Greenscape Development Corporation Subdivision

Salem, Connecticut

**EASTERN CONNECTICUT
ENVIRONMENTAL
REVIEW TEAM
REPORT**

GREENSCAPE DEVELOPMENT CORPORATION SUBDIVISION
SALEM, CONNECTICUT

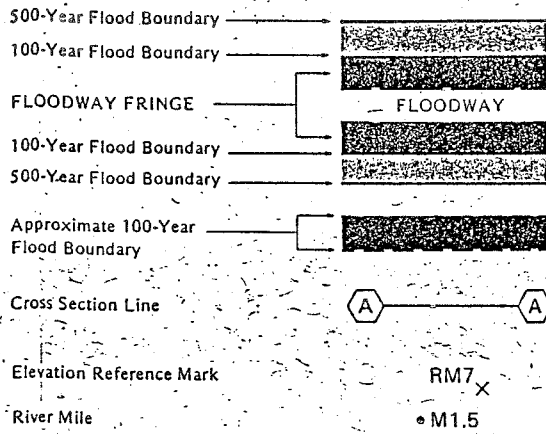
Lot 16. The house proposed for this lot would be mostly surrounded by wetlands, additionally, the house and septic could not be constructed outside of the setback/buffer zone. Due to the proximity of the house and septic area and the long expanse of the driveway to the wetlands there could be significant impacts to the wetlands during the construction activities, eg. clearing, and grading. Additionally, secondary impacts by the homeowner would compound these impacts, eg. a desire for a larger lawn or a garden could lead to the inadvertent clearing of wetland vegetation and possibly fringe wetland filling. This lot should be eliminated and combined with the wetland area to the west and subsequently deeded as open space.

Lot 17. Impacts could be reduced for this lot by modifying the lot lines for lots 18 and 19 to move the proposed house out of the buffer area and away from the wetlands.

Lots 39 and 41. As currently proposed, there is insufficient buildable land on either lot to provide adequate area for the construction of a house and septic area. If the two lots were combined into one lot, there should be sufficient area for one house and septic system.

Lots 30, 31 & 32. As shown on the plans the driveways would not impact the wetlands. A different alignment of the driveways (ie. to cross the wetlands from the road that the lots will front on) would result in significant impacts to the wetlands.

Lots 24, 25 & 26. House, septic and well locations are not shown, nor does it appear that test pits have been dug for these lots. In order for impacts to be properly evaluated for these three lots, these are preliminary steps which must be taken by the applicant.
